ADDENDUM 2

CSP 22-68

Memorial Middle School Heating & Air Condition (HVAC) Improvements Funded through the Elementary & Secondary Emergency Relief (ESSER) Funds

April 8, 2022

8 LEVEL 1G DEMO EXRTU-19 AND EXRTU-20
MD3.12 1/4" = 1'-0"

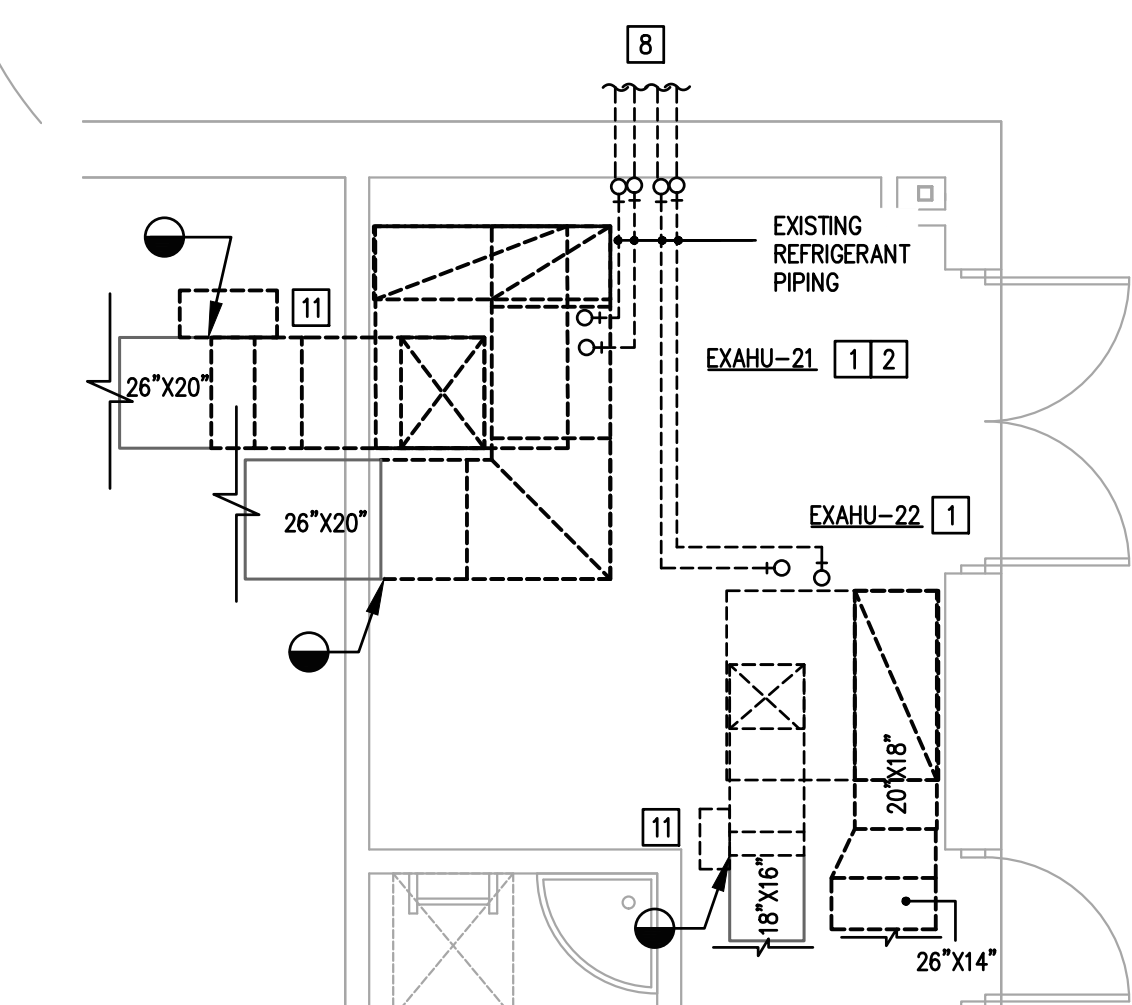
Item 05 SHEET MD3.12 – ENLARGED MECHANICAL DEMO PLAN

A. Revised keyed notes 3 and 10.

SHEET NUMBER:
MD3.13

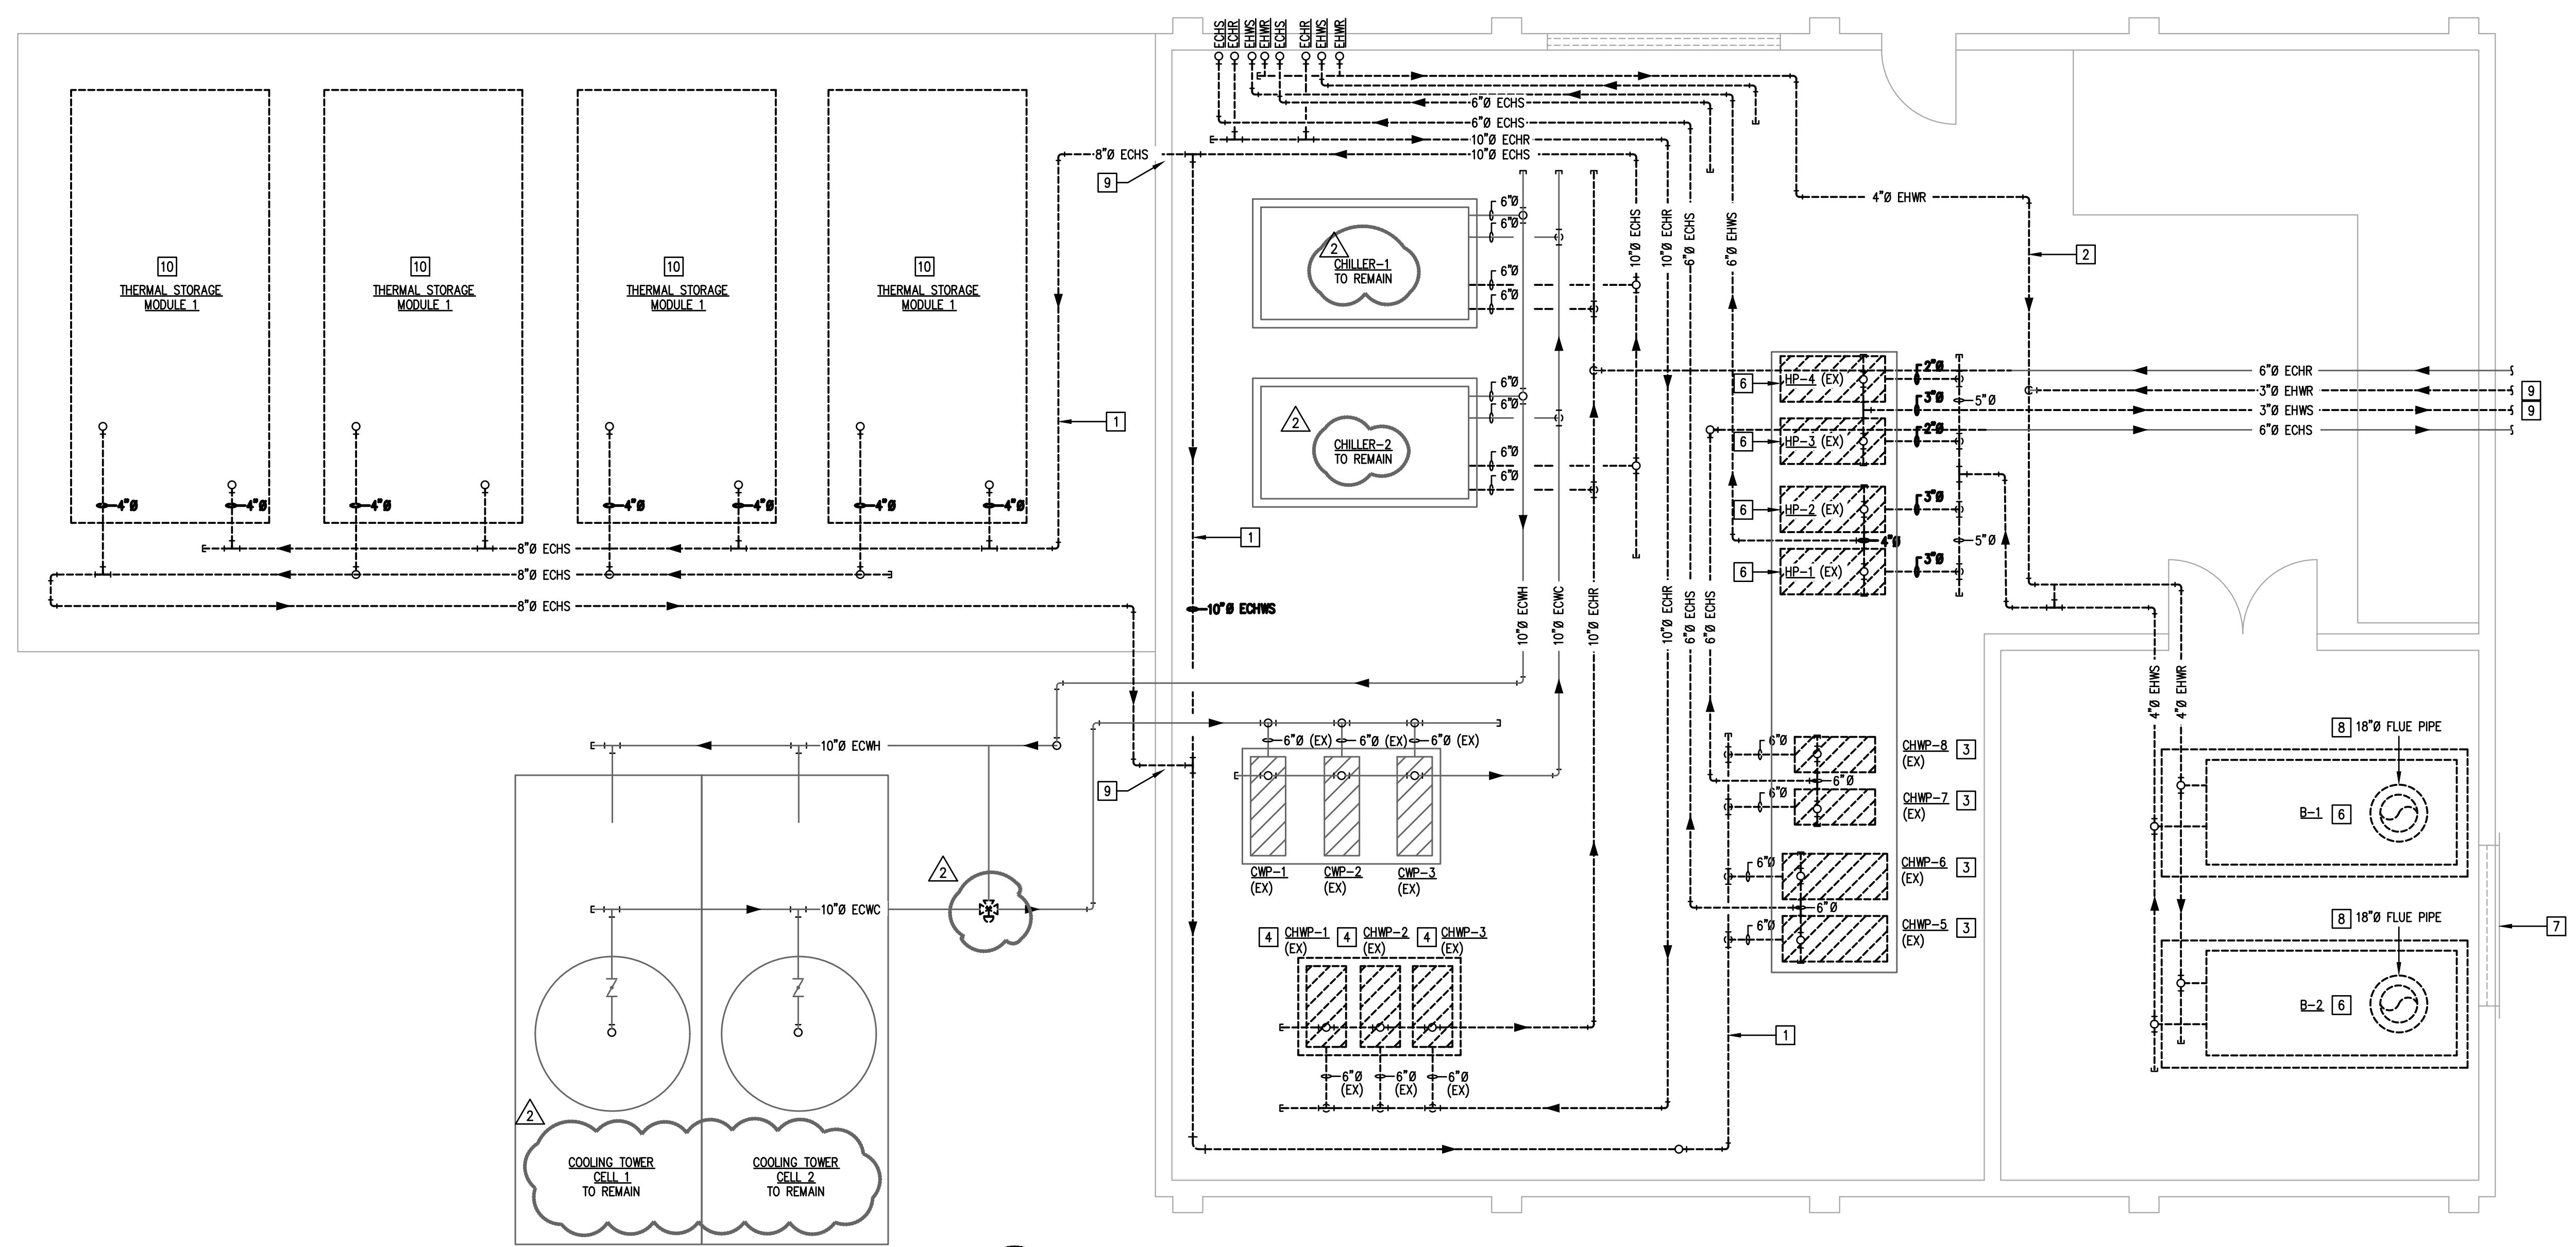
Item 06 SHEET MD3.13 – ENLARGED MECHANICAL DEMO PLAN

A. Scheduled cooling tower 3-way valve to be demolished.

B. Clarified that the chillers and cooling towers to remain.

C. Revised keyed note 6.

COMPOSITE LEVEL 1 MECHANICAL HYDRONIC PIPING PLAN
 3/32" = 1'-0"

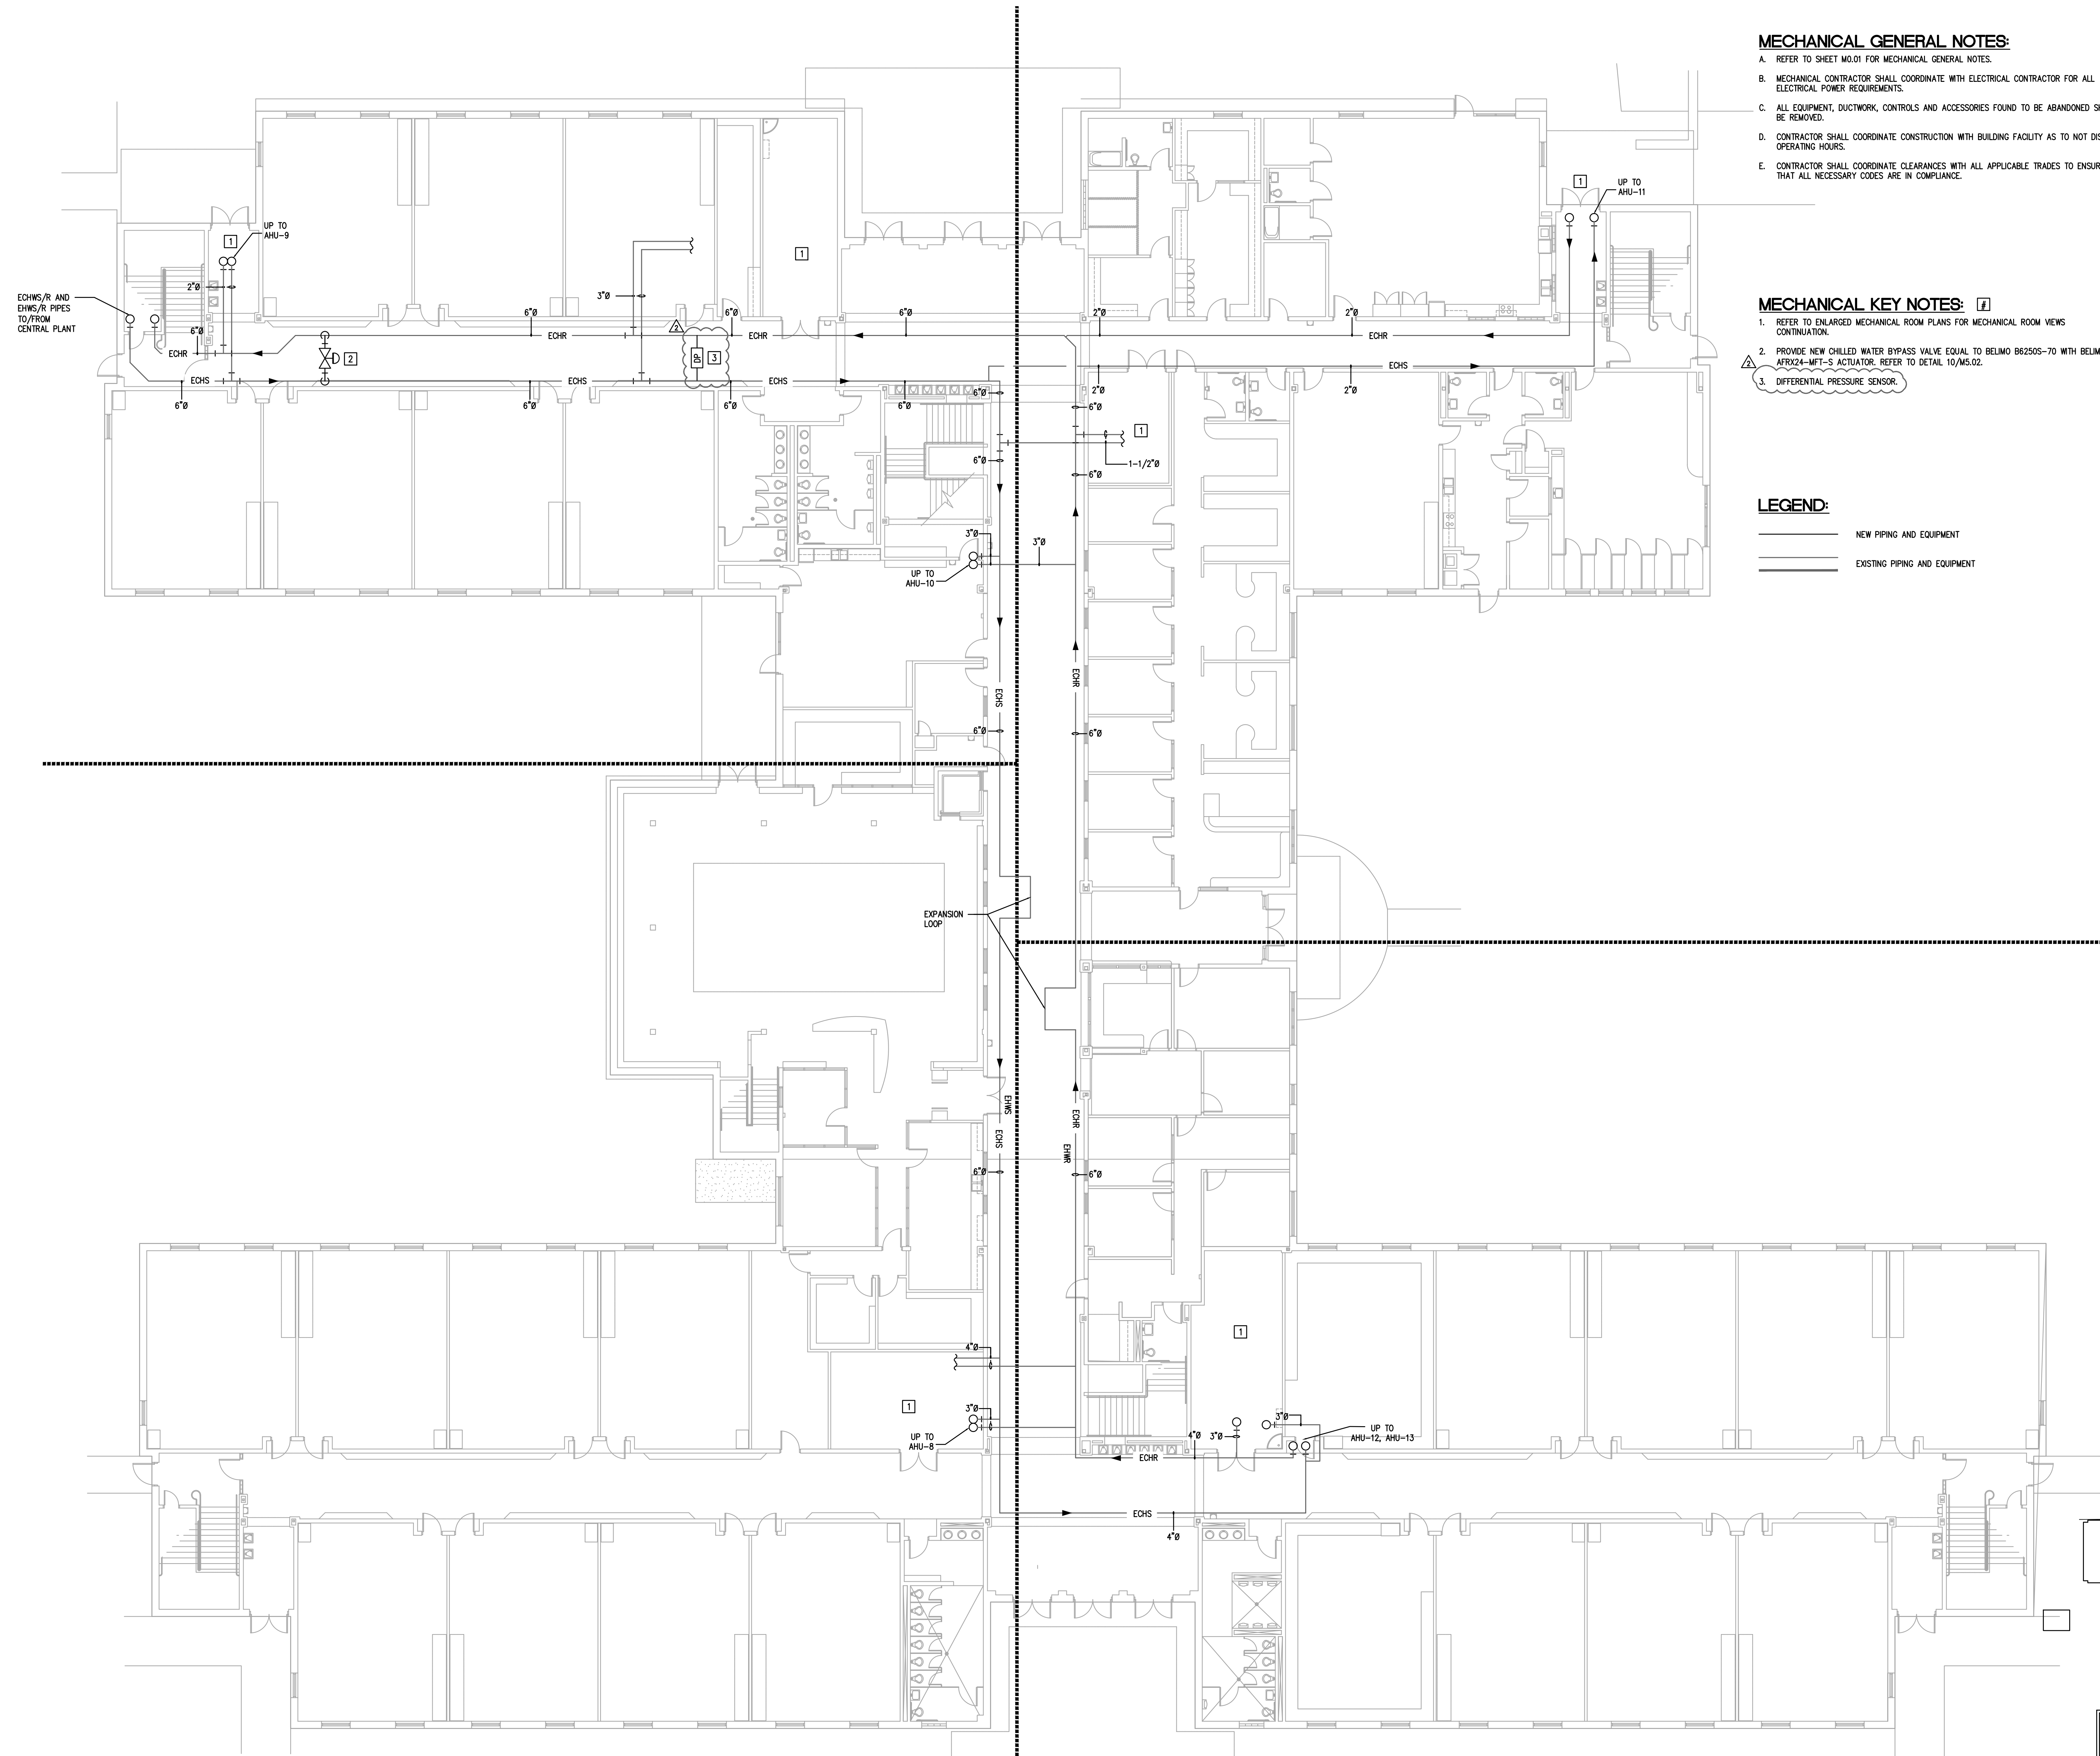
Item 07 SHEET M1.11 – COMPOSITE LEVEL 1 MECHANICAL HYDRONIC PIPING PLAN

A. Added differential pressure sensor.

- 1. REFER TO ENLARGED MECHANICAL ROOM PLANS FOR MECHANICAL ROOM VIEWS CONTINUATION.
- 2. PROVIDE NEW CHILLED WATER BYPASS VALVE EQUAL TO BELIMO B62505-70 WITH BELIMO AF824-MFT-S ACTUATOR. REFER TO DETAIL 10/MS.02.
- 3. DIFFERENTIAL PRESSURE SENSOR.
